Legal Metrology
Branch

File N°: 06635
Project: AP-GL-91-0020

This is in response to your recent notification given in accordance with the Electricity and Gas Inspection Regulations, Section 13. It is noted that the meters listed in the appendix hereto are to be fitted with plastic index covers.

HANDHOLE COVER AL-225/ AL-425

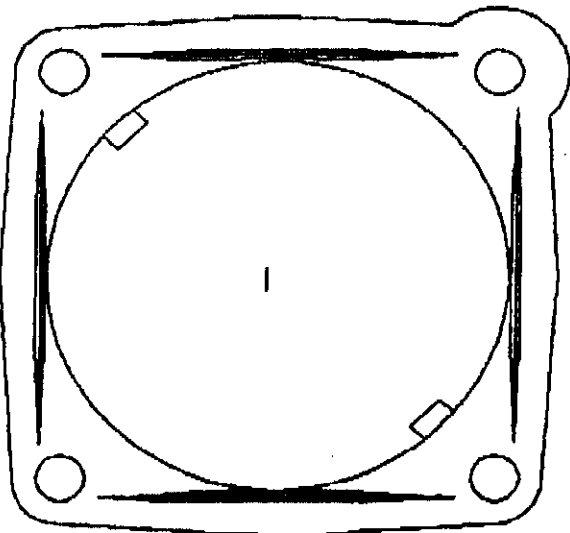
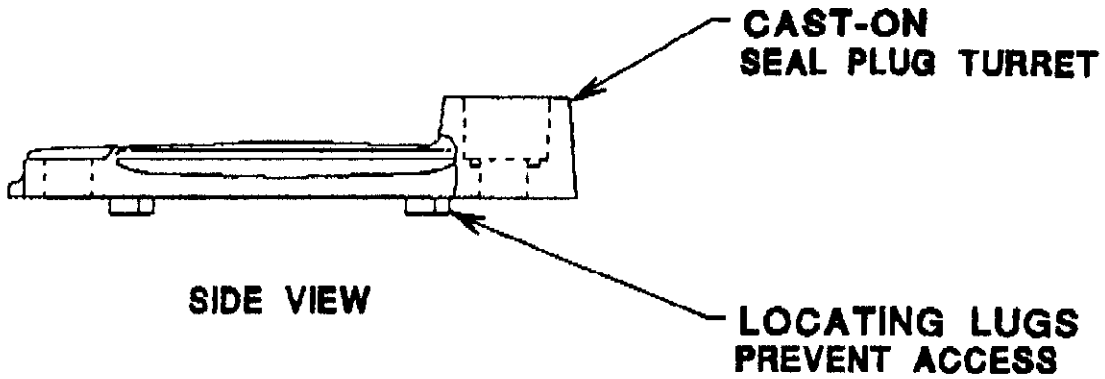
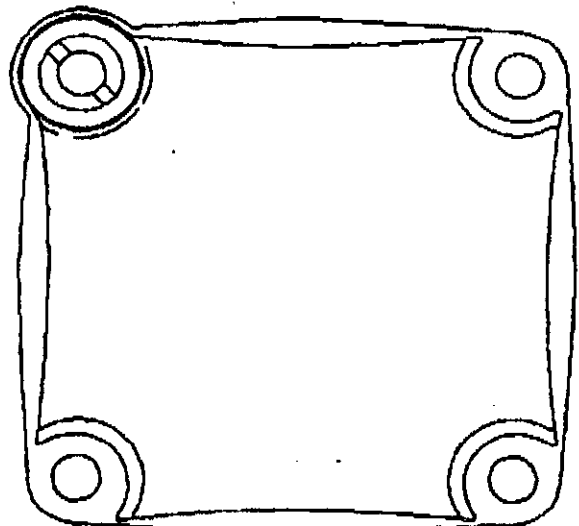
- Affixing of new die-cast hand hole cover with a cast receptacle to accommodate an encasement type seal.

I am advised by the Gas Metrology Laboratory that their evaluation of the proposed modifications indicates that they do not adversely affect the performance of the meter. Accordingly, your notification is acknowledged and the modifications are accepted as being included within the above-noted approval. All recipients of the approval notice are being informed by copy of this letter.

HANDHOLE COVER AL-225/AL-425
Couvercle trou de main AL-225/AL-425

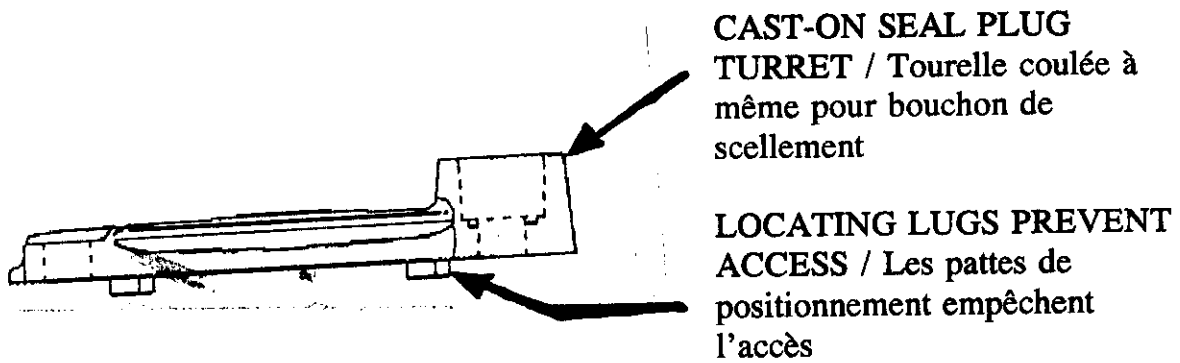
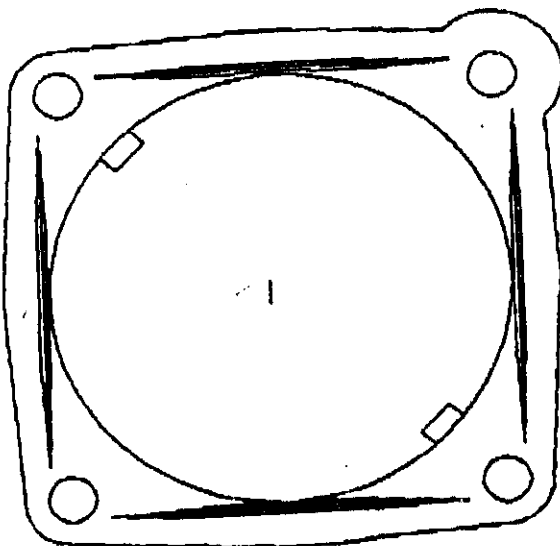
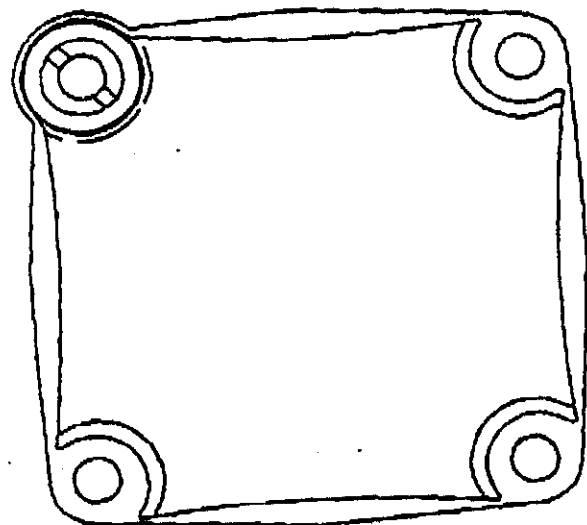
- Fixation d'un nouveau couvercle trou de main coulé sous pression avec logement coulé à même pour sceau de type à emboîtement.

Après avoir étudié les modifications proposées, le Laboratoire du gaz (métrologie) me signale que ces modifications ne nuisent pas au rendement des compteurs. En conséquence, les modifications sont acceptées et intégrées de facto dans les avis d'approbation susmentionnés. Tous ceux qui ont reçu les avis d'approbation sont avisés de cette décision par un copie de la présente lettre.

Project: AP-GL-94-0024
Date: 1994-08-19

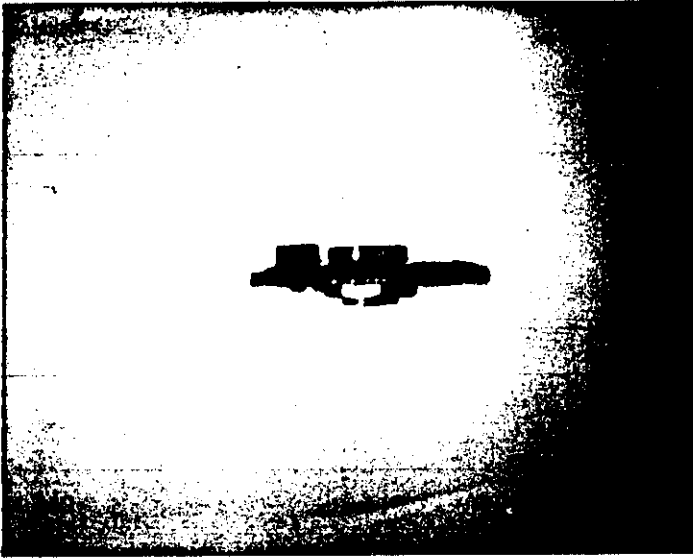
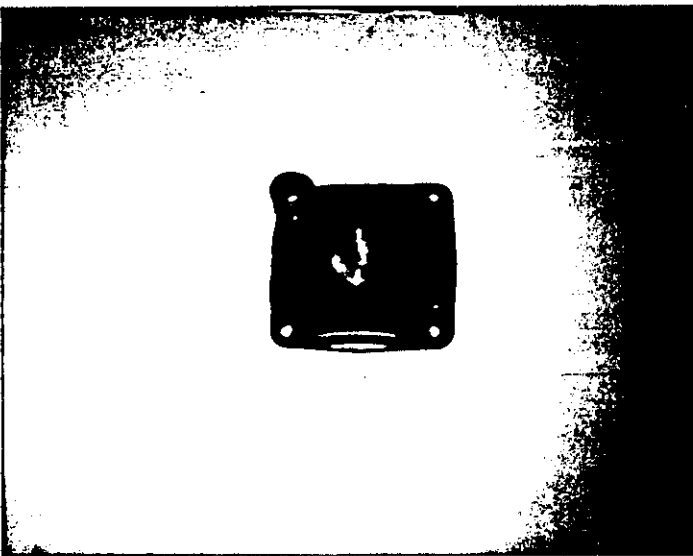
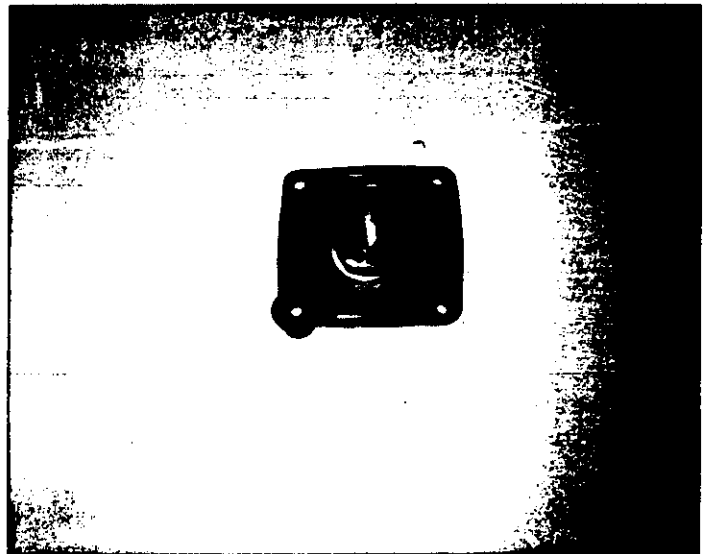
It is noted that these AL-225 and ALM-225 new and re-manufactured meters may be fitted with a pressure tap in the handhole cover. The current die-cast handhole plate may be modified to accept a 1/4" NPT tapped bulkhead adaptor with a sealing washer. Refer to page 2 for photos of the pressure tap in the handhole cover.

I am advised by the Gas Metrology Laboratory that their evaluation of the proposed modifications indicates that they may do not adversely affect the performance of the meter. Accordingly, your notification is acknowledged and the modifications are accepted as being included within the above-noted approval. All recipients of the approval notice are being informed by copy of this letter.

Project: AP-GL-94-0024

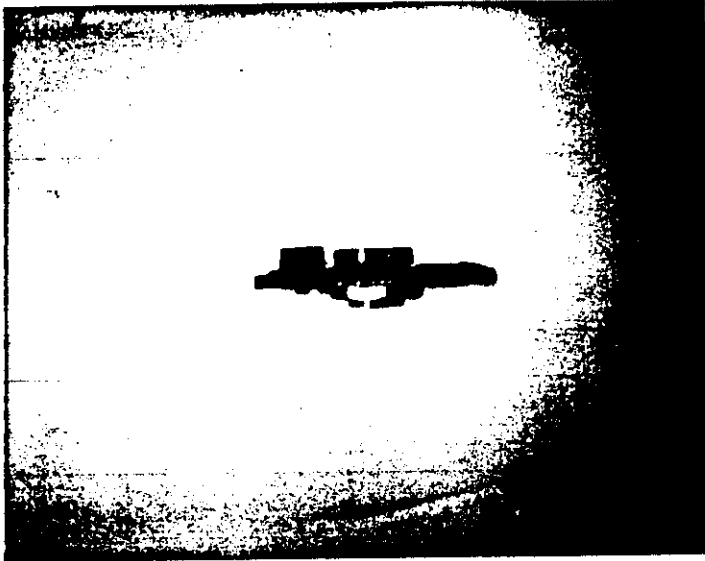
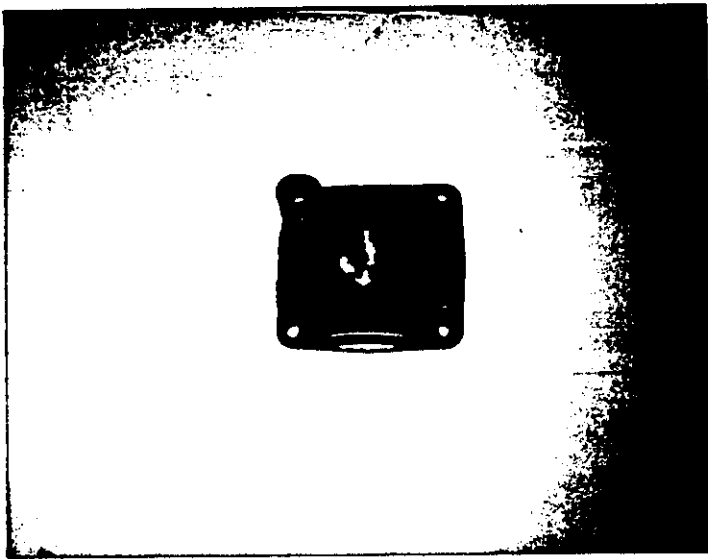
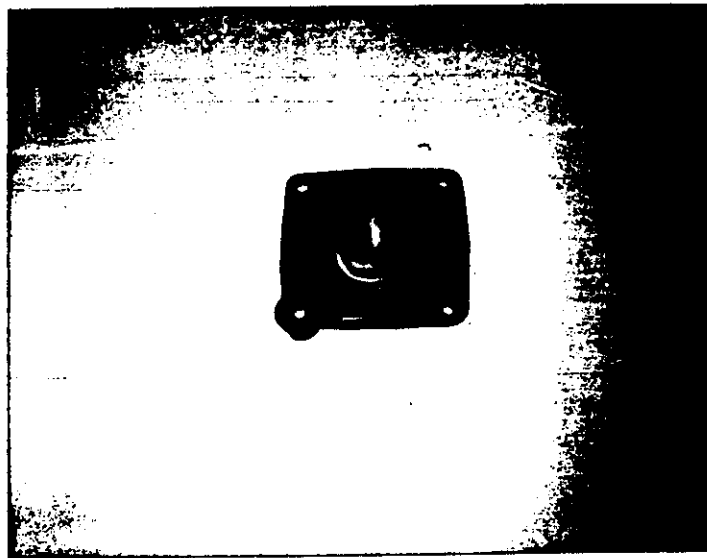
It is noted that these AL-225 and ALM-225 new and re-manufactured meters may be fitted with a pressure tap in the handhole cover. The current die-cast handhole plate may be modified to accept a 1/4" NPT tapped bulkhead adaptor with a sealing washer. Refer to page 2 for photos of the pressure tap in the handhole cover.

I am advised by the Gas Metrology Laboratory that their evaluation of the proposed modifications indicates that they do not adversely affect the performance of the meter. Accordingly, your notification is acknowledged and the modifications are accepted as being included within the above-noted approval. All recipients of the approval notice are being informed by copy of this letter.
